**To:** Patricia Davis, P.E., Brad Marshall  
**From:** Jonathan Tran, P.E. / Charles Cameron  
**Copy:** Matt Gaughan, P.E.  
**Date:** June 11, 2020  
**Subject:** CWWTP1 Change Order 0001

For the Central Wastewater Treatment Plant Expansion project, the Owner's Representative Team recommends approval of the attached Change Order 0001 in the amount of \$288,607.76 and 34 additional days to the contract with BAR Constructors, Inc. for the nine items in Table 1 below.

<b>Project:</b> <u>Central Wastewater Treatment Plant</u>	<b>Project Number:</b> _____
<b>Owner:</b> <u>City of Pflugerville</u>	<u>88</u>
<b>Contractor:</b> <u>BAR Constructors</u>	<u>279</u>
<b>Engineer:</b> <u>Freese and Nichols</u>	<u>PFL16607</u>
<b>PCM:</b> <u>Plus Six Engineering</u>	<u>19-211</u>

**Change Order No.:** 001      **Date:** 06/11/2020

CITY OF PFLUGERVILLE  
**CENTRAL WWTW EXPANSION**  
**PHASE I IMPROVEMENTS**  
 CIVIL  
**PHASE I PLANT LAYOUT**

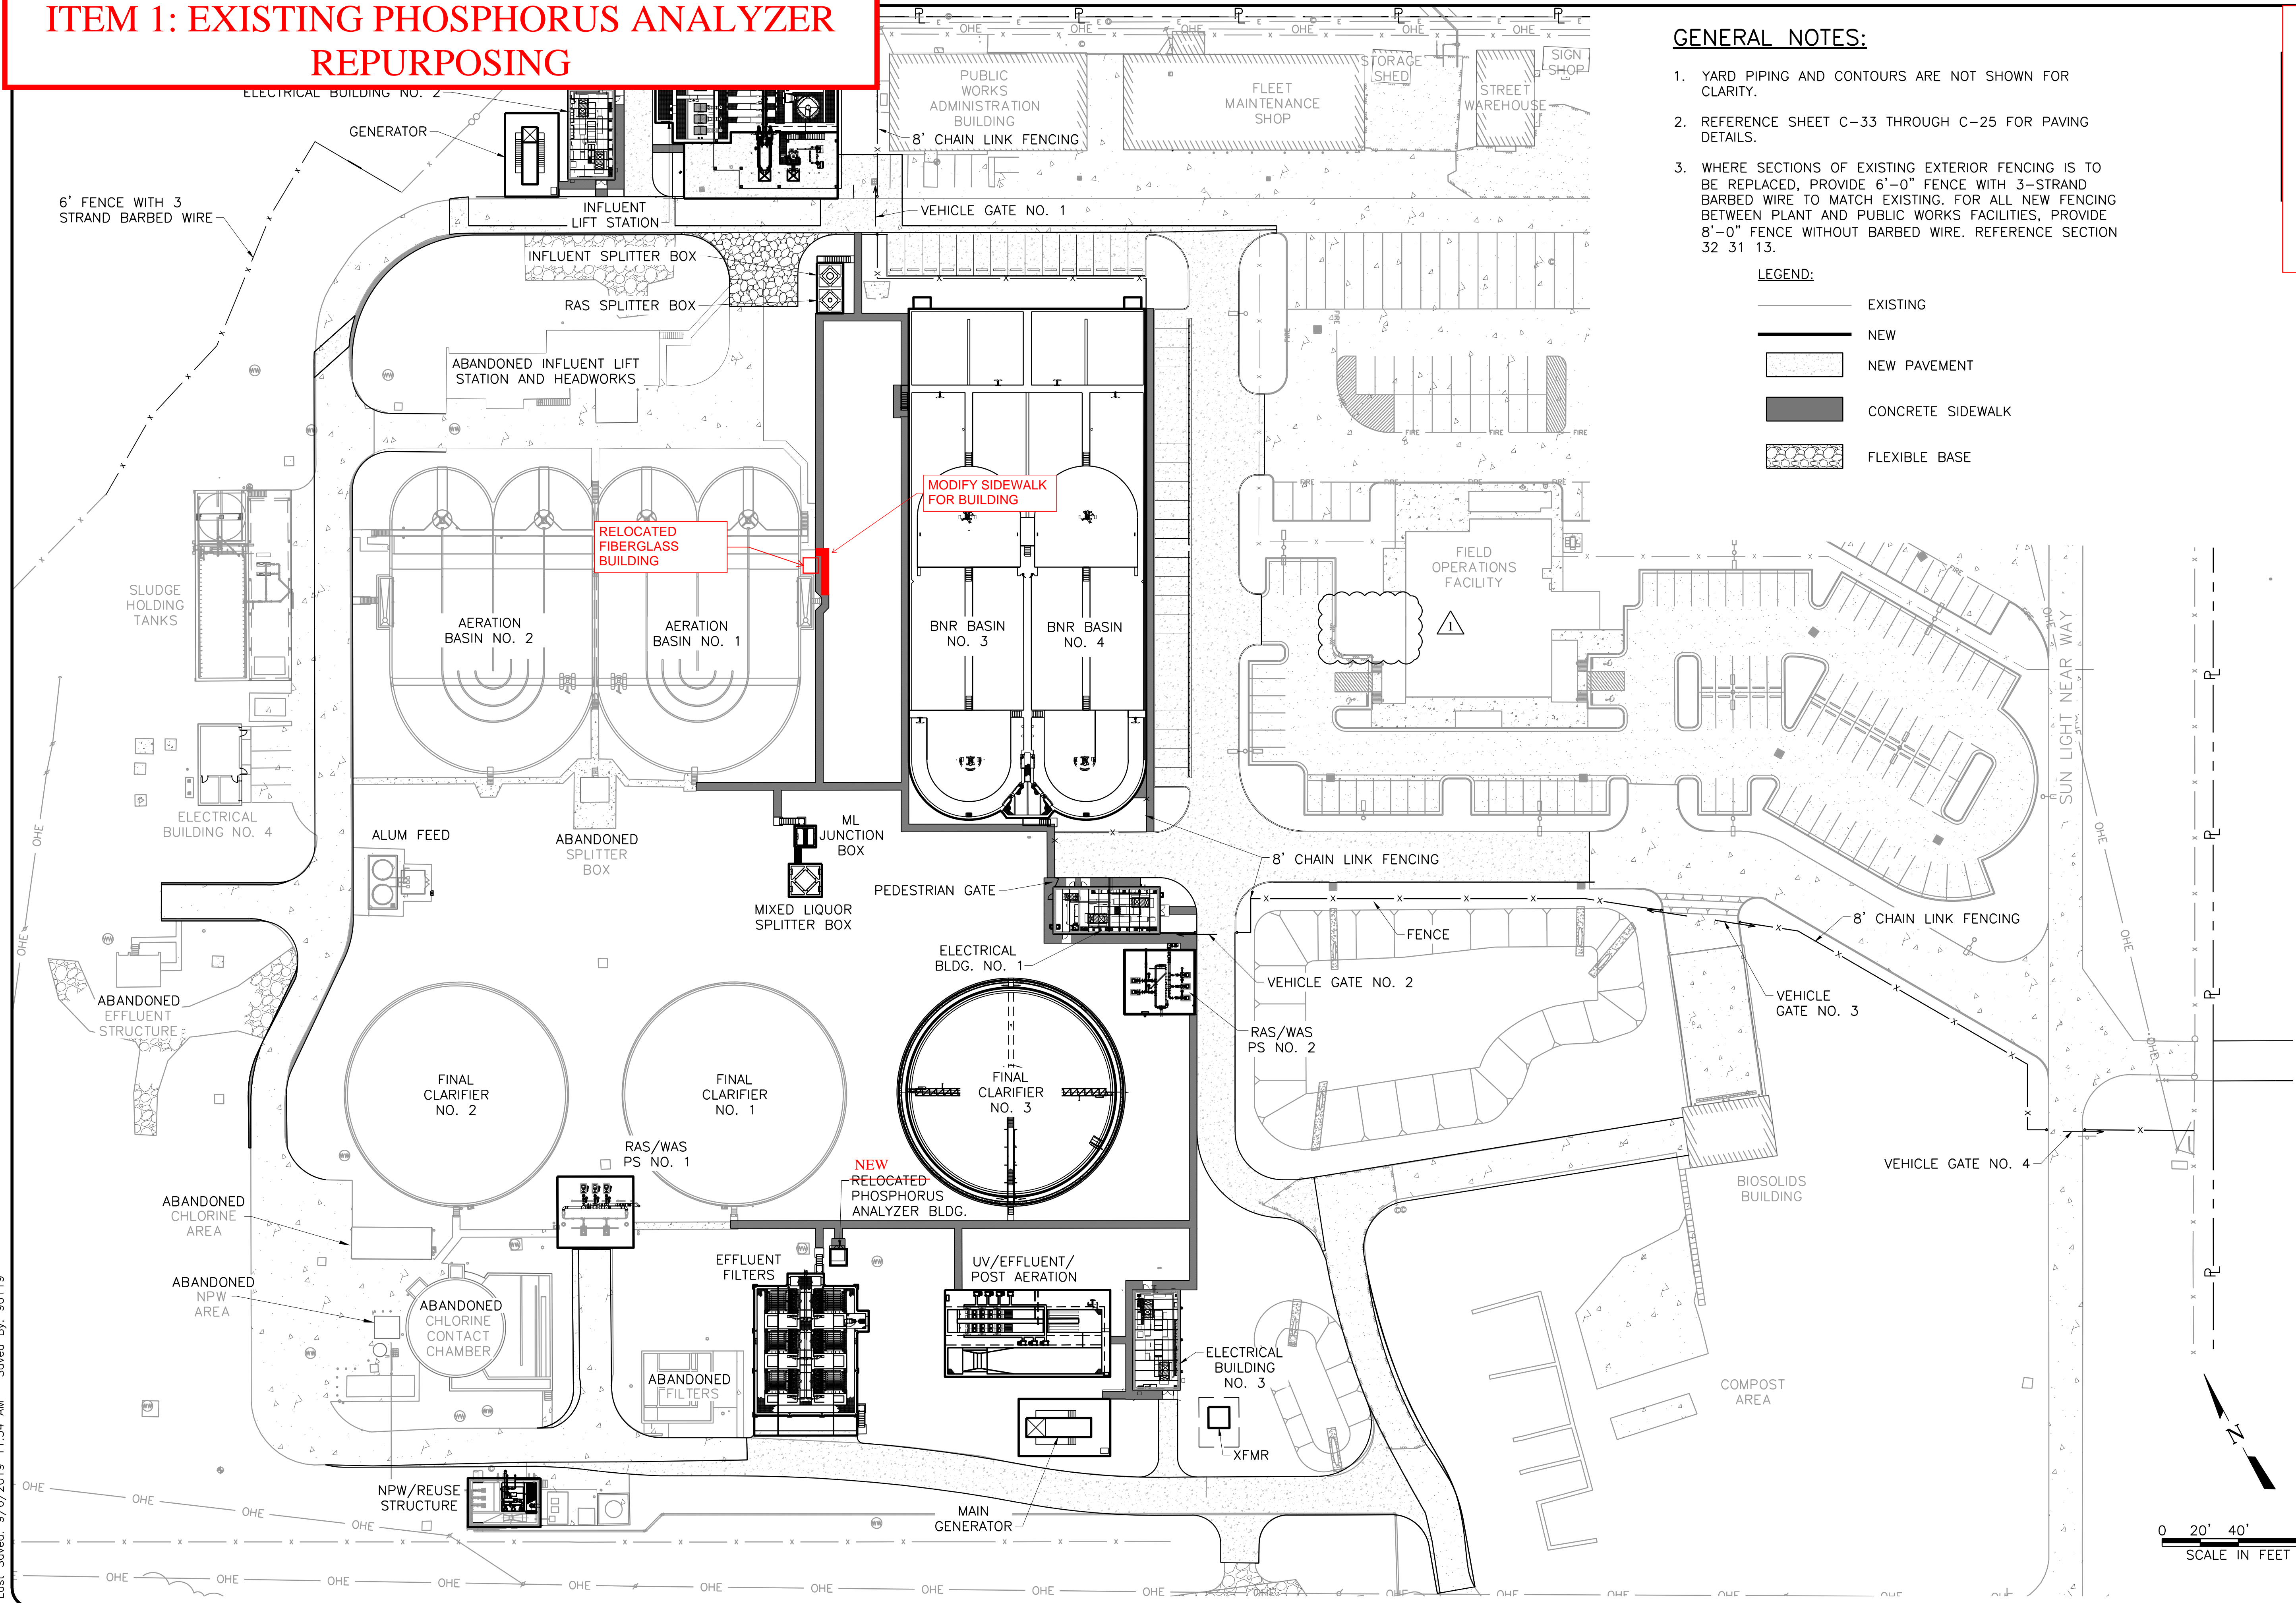
Relocate the existing phosphorus analyzer, piping, HVAC equipment, lighting, and fiberglass housing to the existing mixed liquor splitter box next to the Aeration Basin #1 effluent box. A new 6' x 6' x 7.5' fiberglass building shall be provided for the new phosphorus analyzer and turbidimeter near the cloth media filters in place of repurposing the existing. Reference the attached markups.

- New 10' x 10' concrete slab for phosphorus analyzer building adjacent to the Aeration Basin #1 effluent box per Detail 6, SD-27.
- New 1" PVC sample line extending from AB #1 effluent box, over the top of the north wall of the effluent box extending down to grade level, then north at grade to the phosphorus analyzer building through existing pipe penetrations on the back of the phosphorus analyzer building. Support piping on concrete basin using 316 SS pipe straps.

- New 2" PVC hub floor drain.
- New 2" PVC drain line extending from below floor of phosphorus analyzer building to 15" drain line located north of the aeration basins.

- New piping tie-in to 15" drain line north of the aeration basins with wye and reducers at connection point of 2" PVC drain and 15" PVC drain.
- Relocate existing sample piping, instrumentation, HVAC equipment, lighting, and phosphorus analyzer building to new concrete slab.

CITY OF PFLUGERVILLE  
**CENTRAL WWTP EXPANSION**  
 PHASE I IMPROVEMENTS  
 CIVIL  
**YARD PIPING PLAN II**

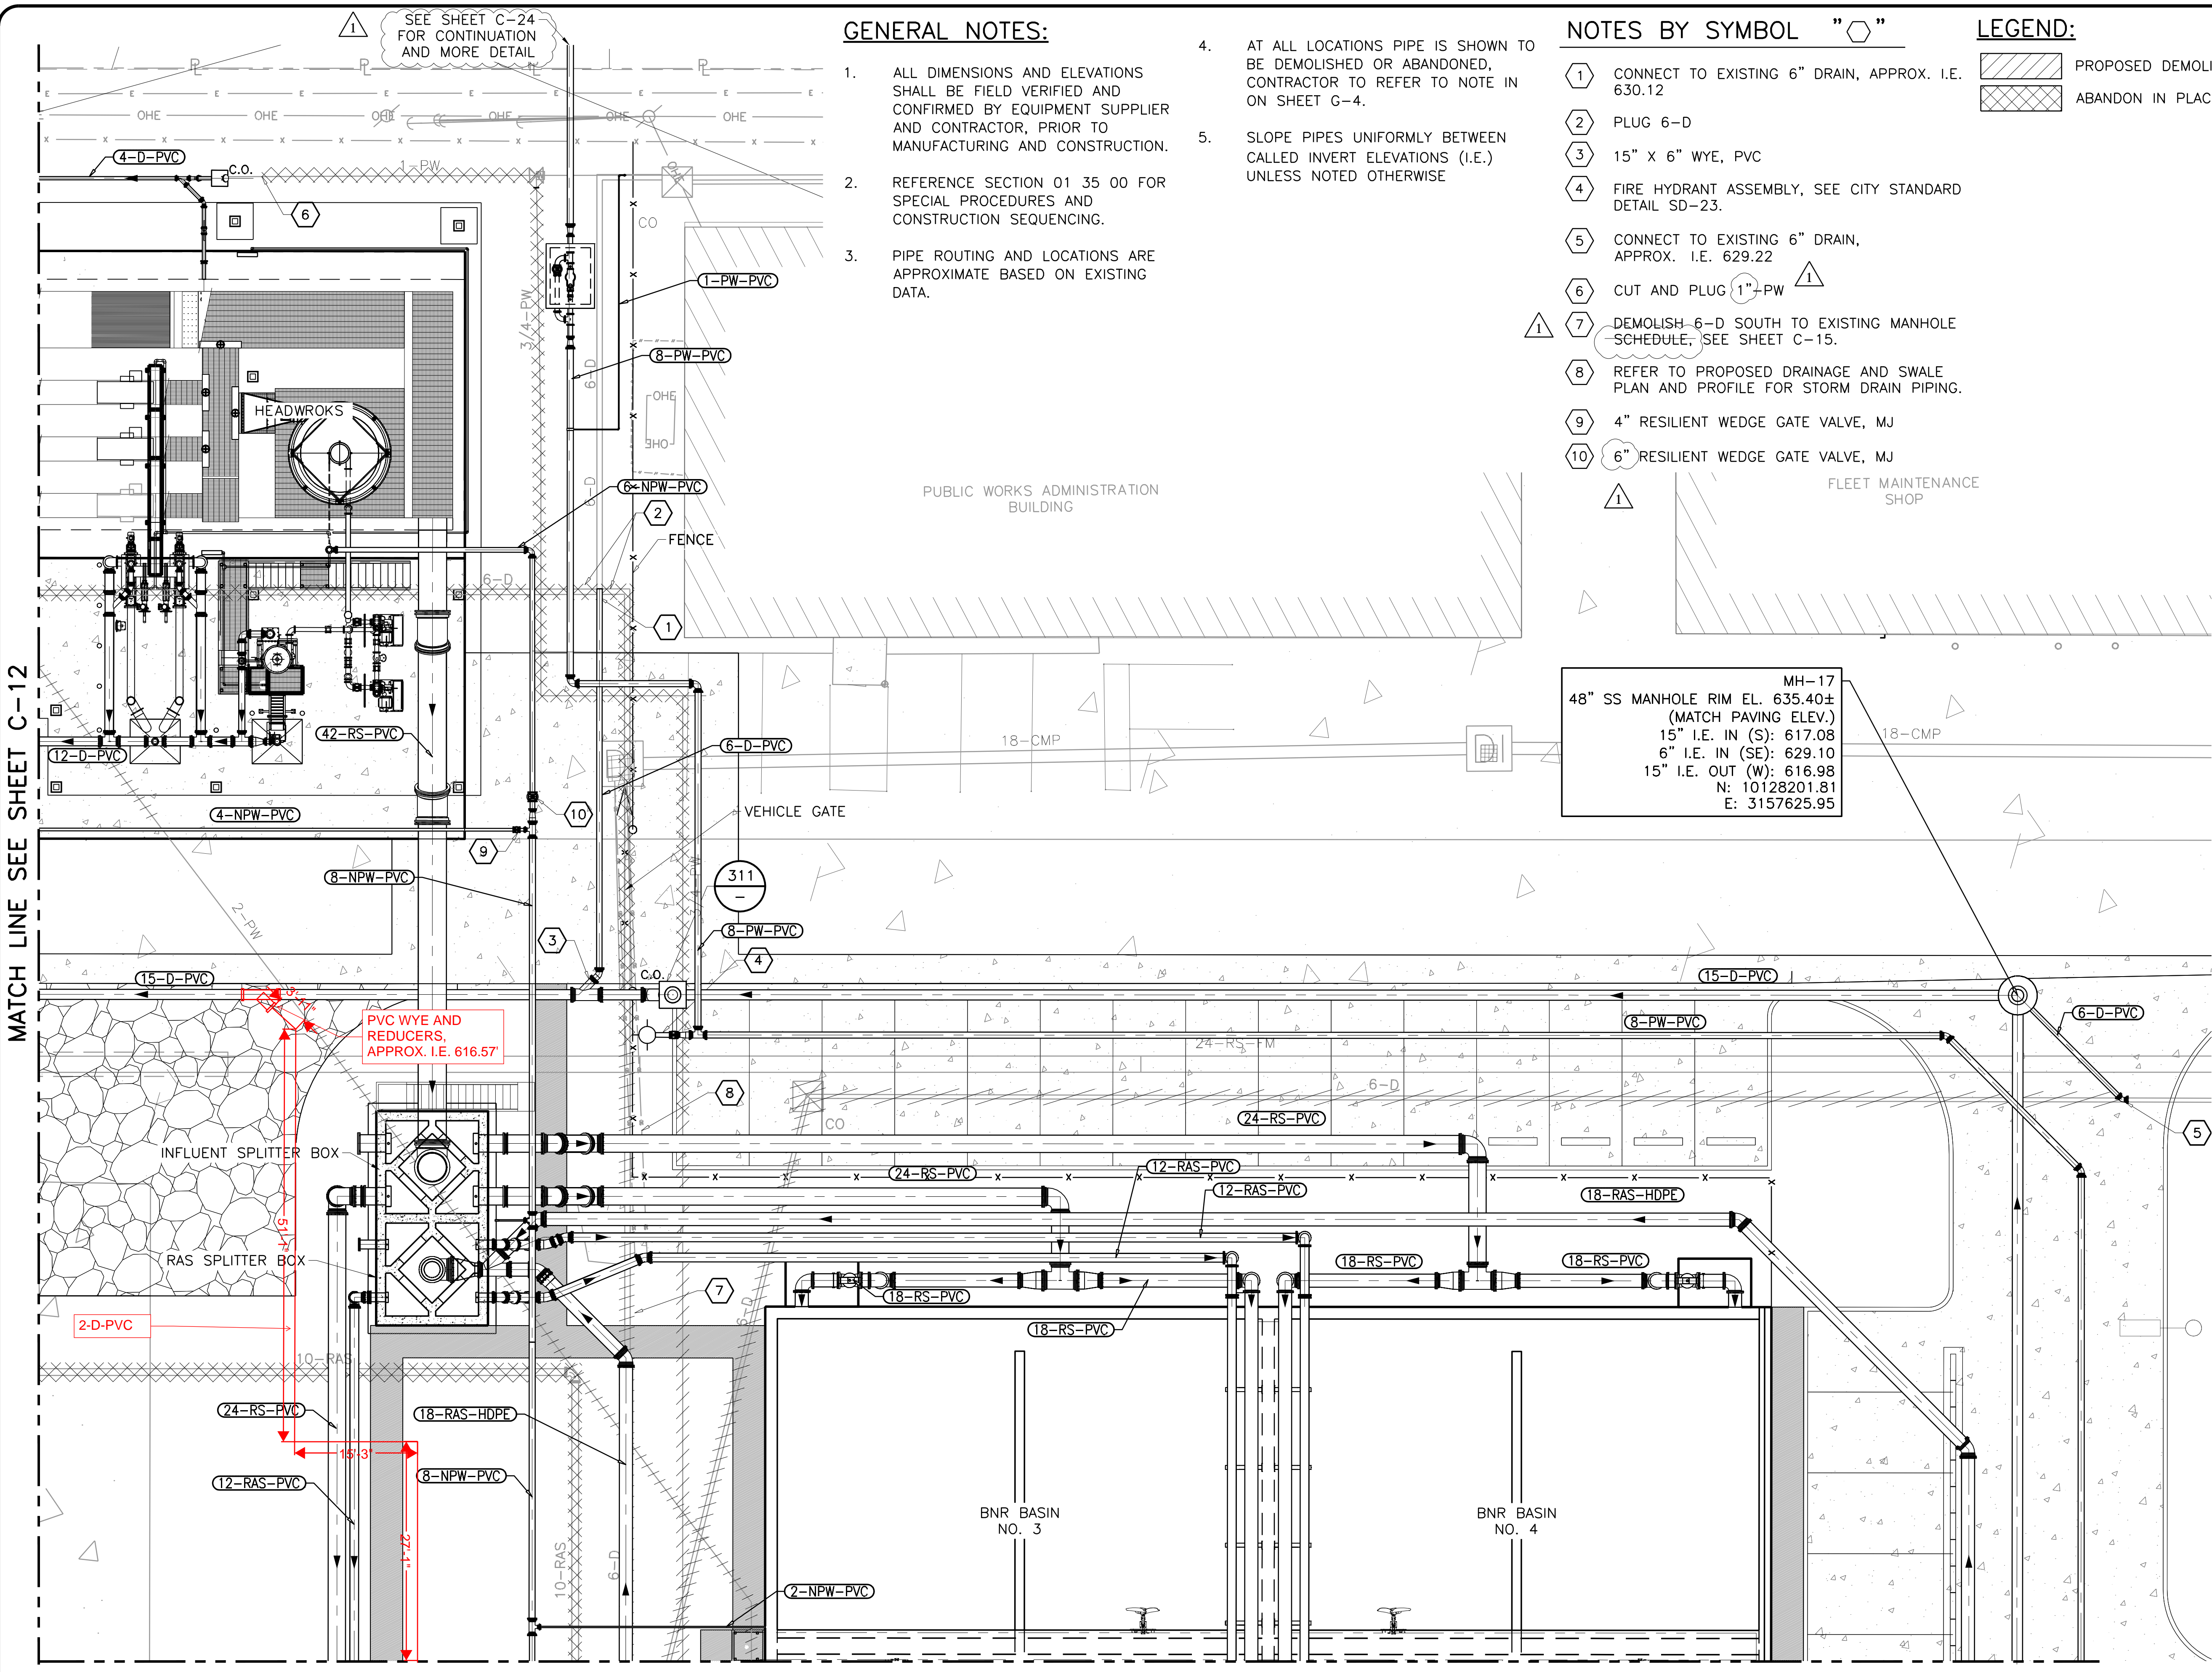
PVC WYE AND REDUCERS, APPROX. I.E. 616.57'
